# Access Compliance Report

### (Curb Ramps)

Intersection ID: 18538	Main Street: SENECA_PL	Cross Street: SOUTH_BV	Location: NE
ADA ID: 5E6E4D4F1F37	Ramp Type: Perp	Initial Pass/Fail: Fail	Overall Compliance: No
Severity Score: 21.25			
Codes/Mitigation Info/Possible Solution		Field Measurements/Component Compliance

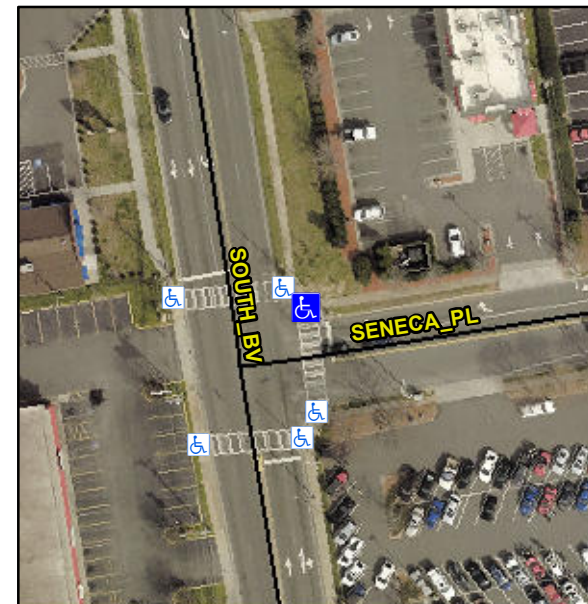
**Not Found, R304.5.1, R304.2.2**

Compliance	Description	Data	Compliance	Description	Data
N/A	Ramp Length (in)	48.0	No	Ramp Slope (%)	8.6
No	Ramp Width (in)	47.0	Yes	Ramp XSlope (%)	1.0
N/A	Flare Type LT	N/A	N/A	Flare Type RT	N/A
N/A	Flare Slope LT (%)	N/A	N/A	Flare Slope RT (%)	N/A
N/A	Flare Traversable LT?	N/A	N/A	Flare Traversable RT?	N/A
N/A	Landing Length (in)	N/A	N/A	DWS Provided?	N/A
N/A	Landing Width (in)	N/A	N/A	DWS Contrast?	N/A
N/A	Landing Slope (%)	N/A	N/A	DWS Length (in)	N/A
N/A	Landing X Slope (%)	N/A	N/A	DWS Full Width?	N/A
N/A	Landing Curb? (Y/N)	N/A	N/A	DWS Offset (in)	N/A
N/A	Shared Landing?	N/A			
N/A	Gutter Ponding?	N/A	N/A	Gutter Slope (%)	N/A
N/A	Gutter Lip Ht (in)	N/A	N/A	Gutter X Slope (%)	N/A
N/A	Painted X Walk1?	Yes	N/A	Painted X Walk2?	N/A
	X Walk 1 Direction	To S		X Walk 2 Direction	N/A
N/A	X Walk 1 Width (in)	112.0	N/A	X Walk 2 Width (in)	N/A
	X Walk 1 Slope (%)	0.9		X Walk 2 Slope (%)	N/A
	X Walk 1 X Slope (%)	0.7		X Walk 2 X Slope (%)	N/A

**Remove & Replace Entire Ramp.**
